MITIGATION PLAN

COOL SPRINGS MITIGATION SITE

Harnett County, NC
NCDEQ Contract No. 0302-02
DMS ID No. 100166

Subject: Mitigation Plan
Cool Springs Mitigation Project, Harnett County
Cape Fear River Basin HUC 03030004
USACE Action ID No. SAW-2020-01400/DWR No. 20201279

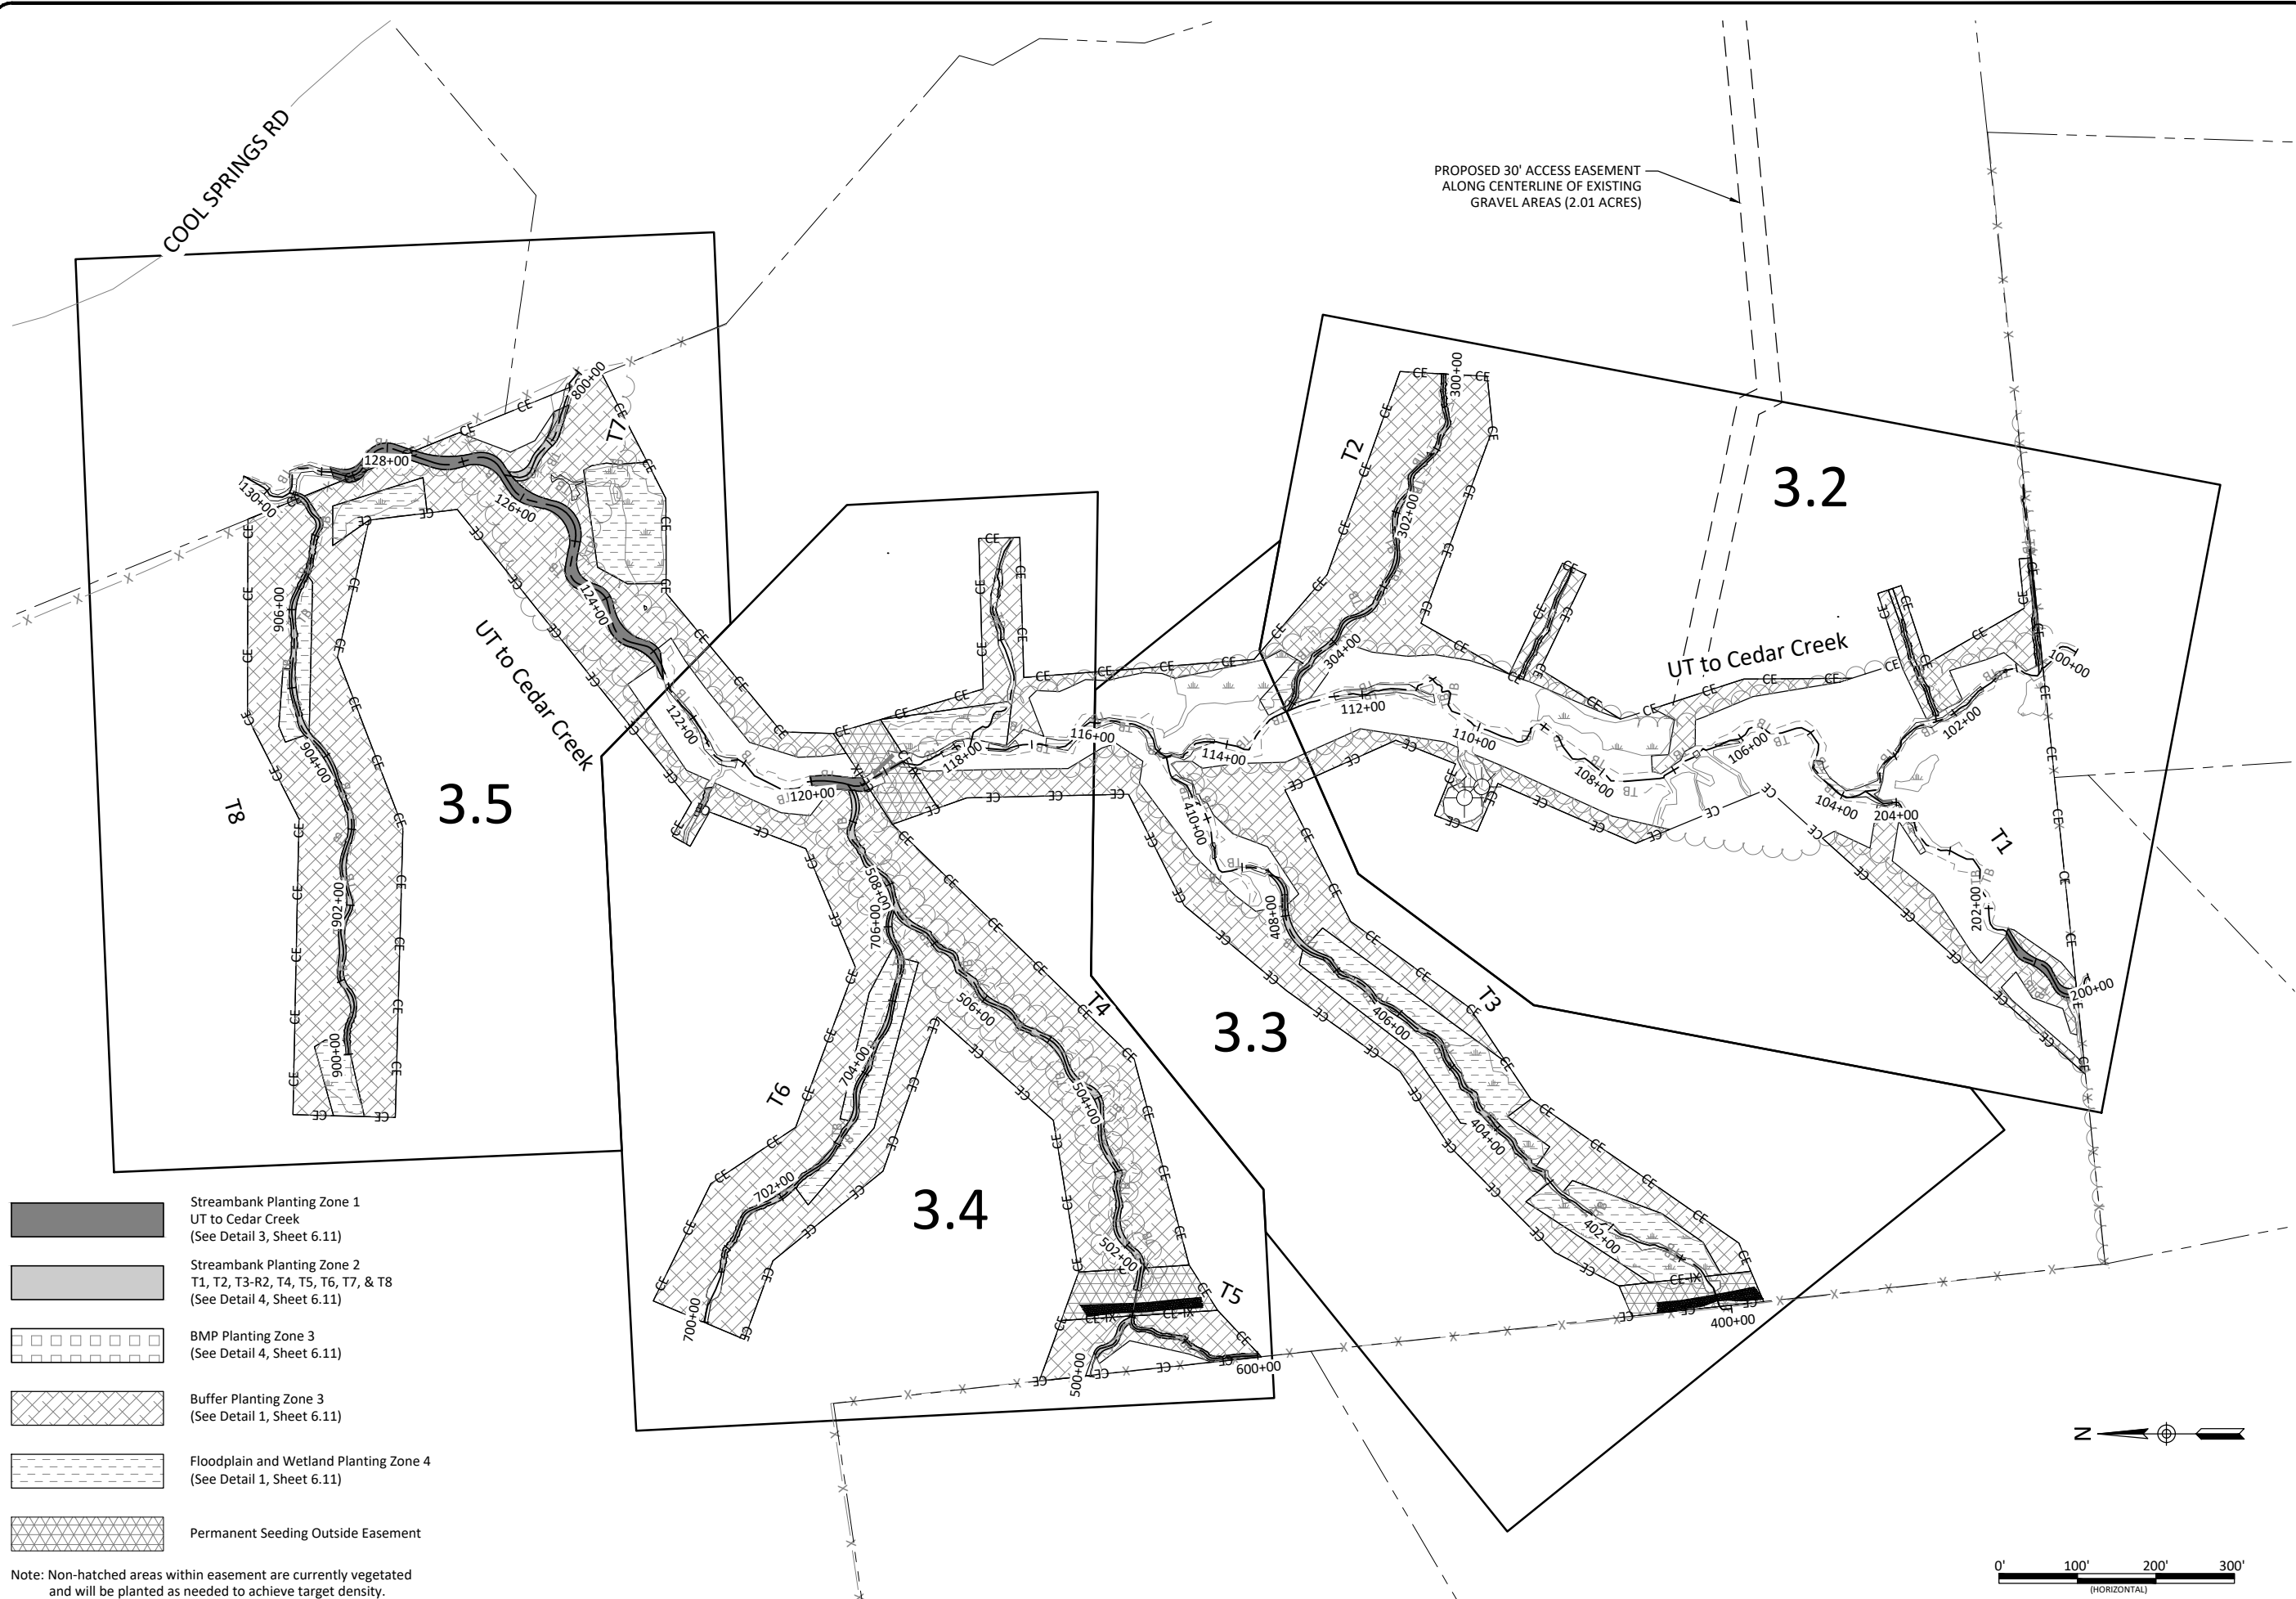
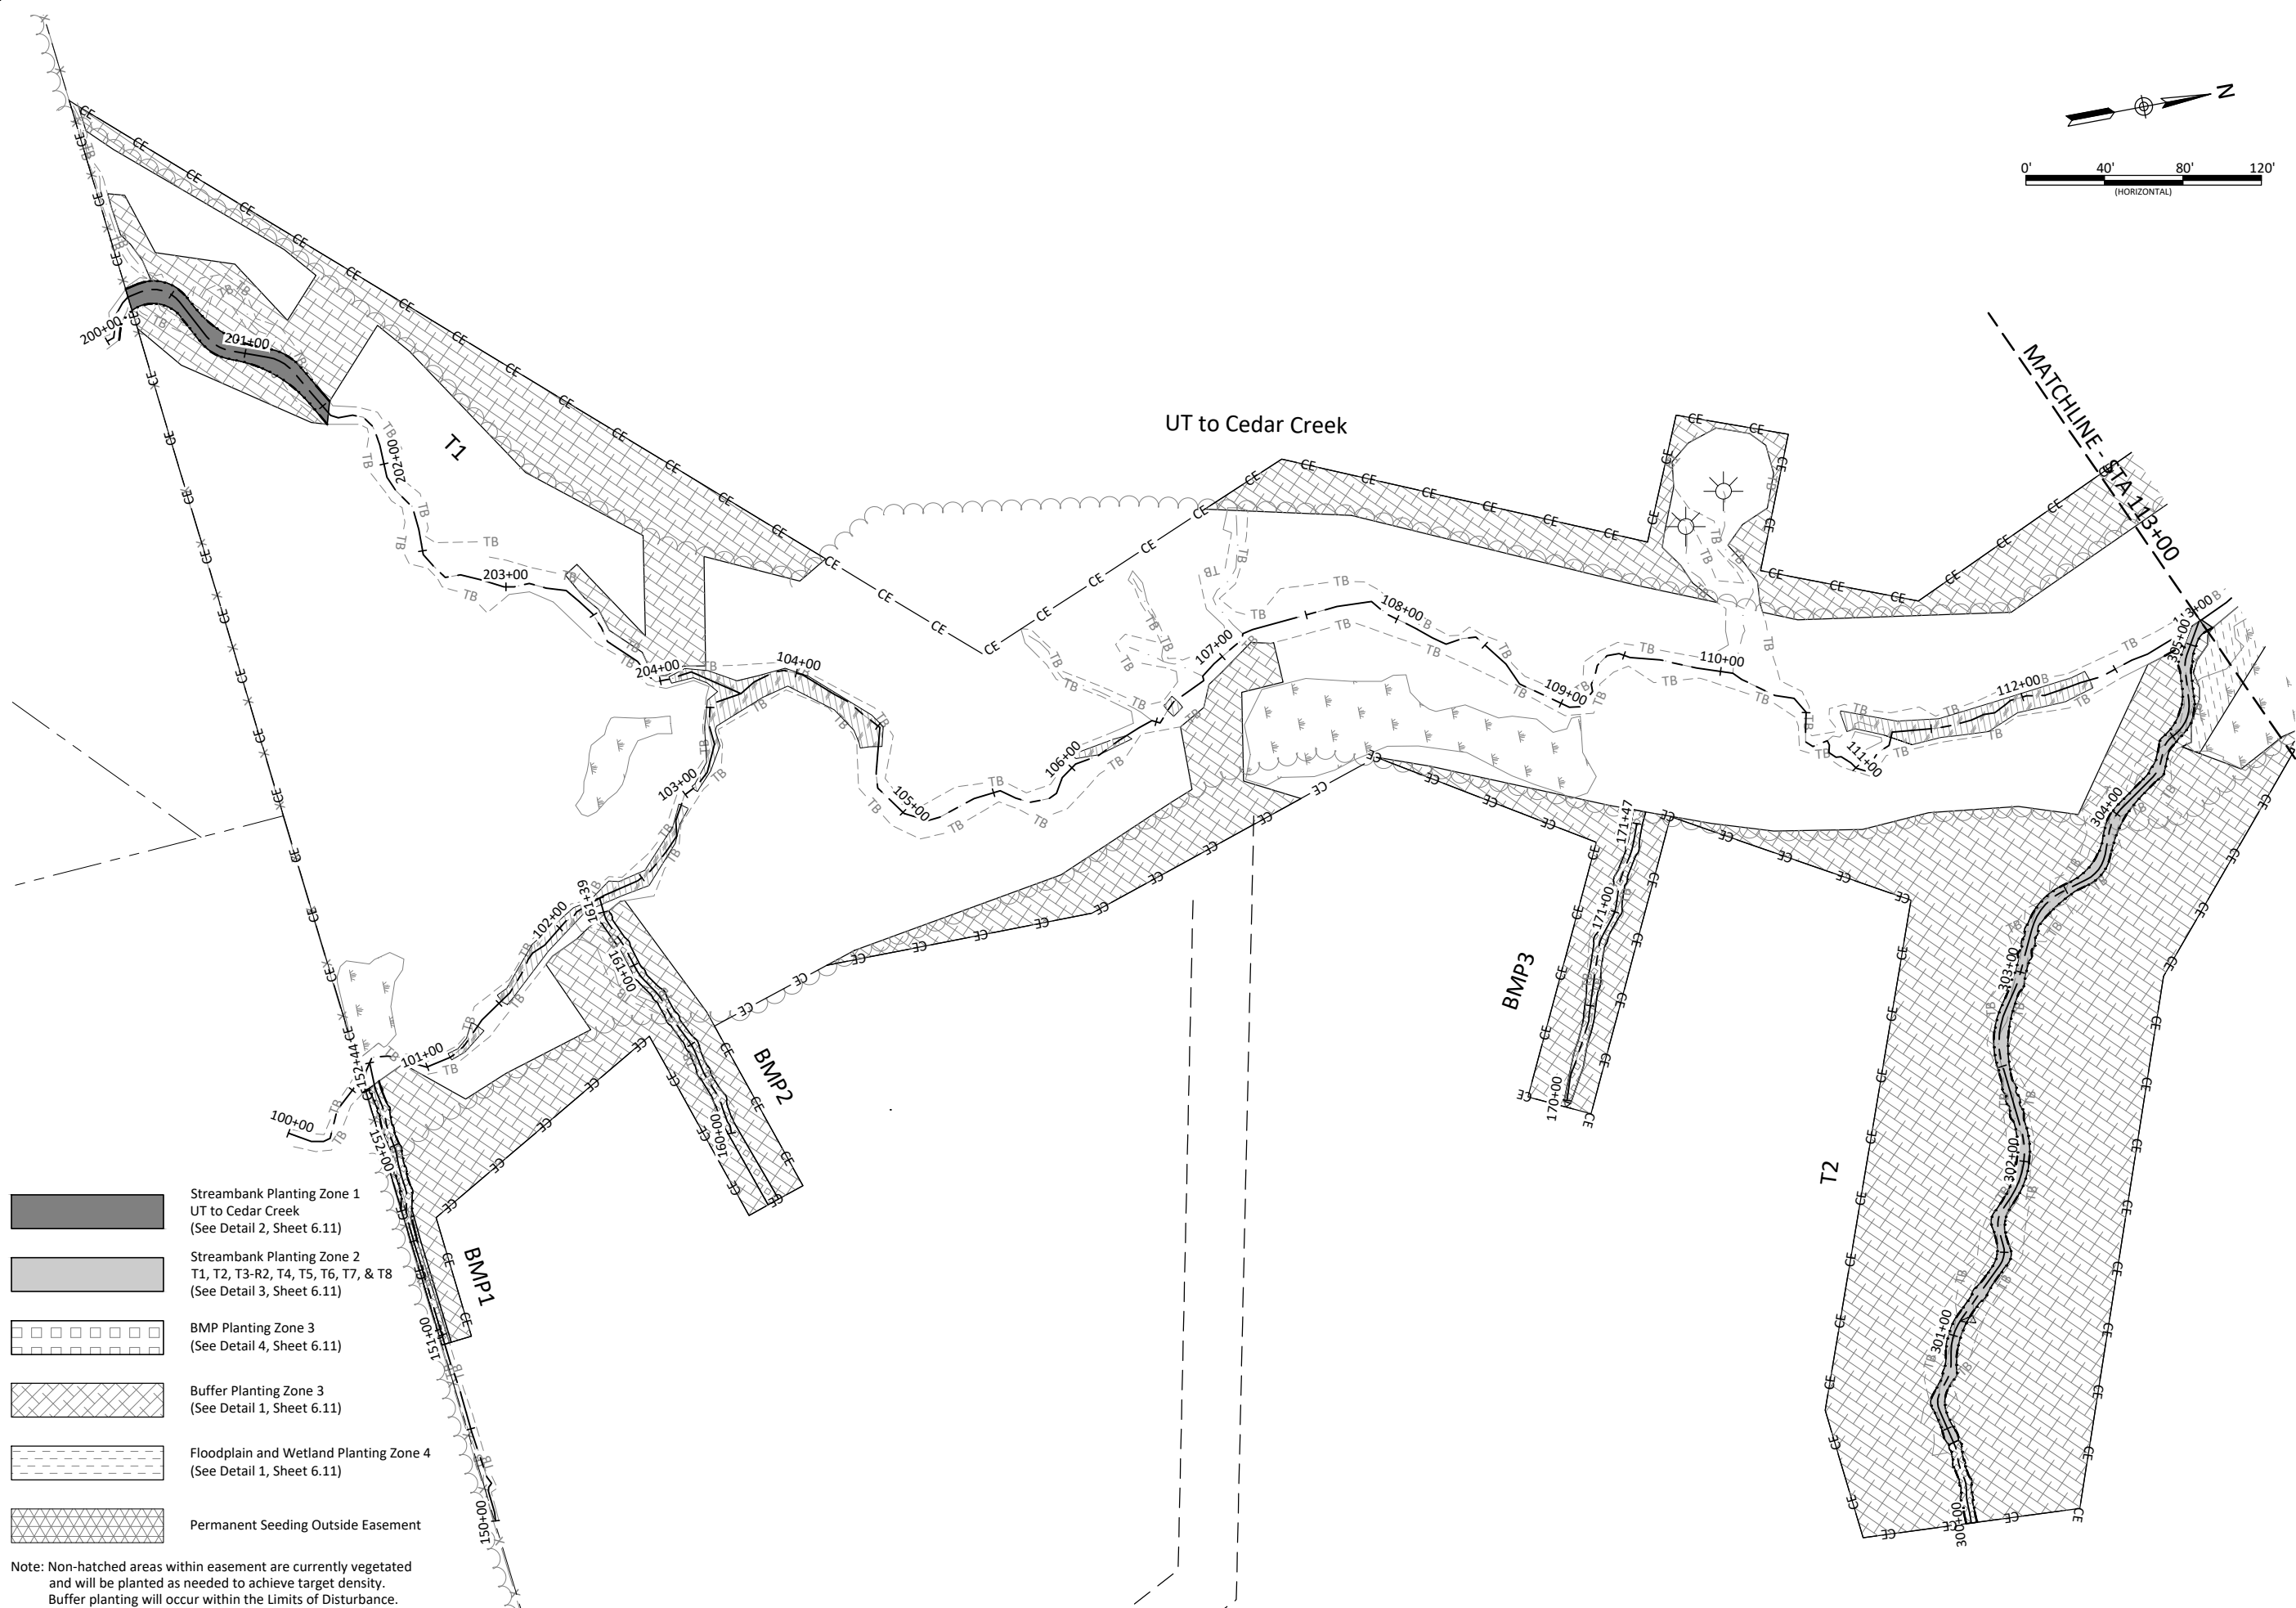
26. Sheet 3.0 – It appears that the buffer planting zone table is missing (unless everywhere beyond the streambank zone is considered the wetland planting zone). DWR requests that an updated version of this sheet be provided for review prior to formally submitting the final mitigation plan.

27. Sheet 3.1 – The planting overview does not show any planting zones or extents (full vs. partial/shaded). This sheet does not have sufficient information for a draft mitigation plan review. DWR requests that an updated version of this sheet be provided for review prior to formally submitting the final mitigation plan.

11. Design Sheets 3.0 and 3.1: Please provide a more detailed planting zone overview. It's difficult to discern which areas will be planted in the wetland zone, especially since several of the permanent riparian herbaceous species are FACU. Providing a figure with the planting zones would be helpful for the review.

The buffer planting zone species list has been added to Sheet 3.0. We provided the updated sheet prior to resubmitting the mitigation plan.

Planting zones have been added to the Planting Overview Sheets. The revised planting sheets were provided to DWR prior to resubmitting the mitigation plan.

The additional planting information including the planting zones is now included on the planting plan sheets. Note that the omission of the buffer planting zone species list has also been corrected.
